**KANEPACKAGE PHILIPPINE INC.**

INVESTIGATION REPORT FORM (IRF)

Customer	BROTHER INDUSTRIES PHILIPPINES, INC.	Attention To	REXEL ALMARIO
Item Code	D028GY001	Department	PRODUCTION
Item Description	CARTON TN FCL X4	Date of Detection	251003
Job Order Number	JO25-M-03051-31	Section Detected	QA SCREENING 3

ILLUSTRATION OF THE PROBLEM

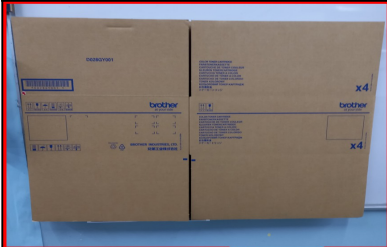
Actual: 4mm Print to creasing
Requirement: 11mm Print to creasing (Tolerance: +/-3mm)

Lot Quantity (pcs)	Reject Qty (pcs)	Reject %
1900	31	1.63
Nature of Defect:		
MISALIGN PRINT		
Requirement:		
11mm Print to creasing (Tolerance: +/-3mm)		
Actual		
4mm Print to creasing

WHY 1 : Misaligned diecut at Eterna.

WHY 2 : Random delayed feeding of materials.

WHY 3 : Stucked up bearing at feeder roller (findings during Eterna machine maintenance c/o Supplier) r nand worn out engineering plastic in the gripper bar causing misalign gripped.

WHY 1: Replacement of worn out machine part..
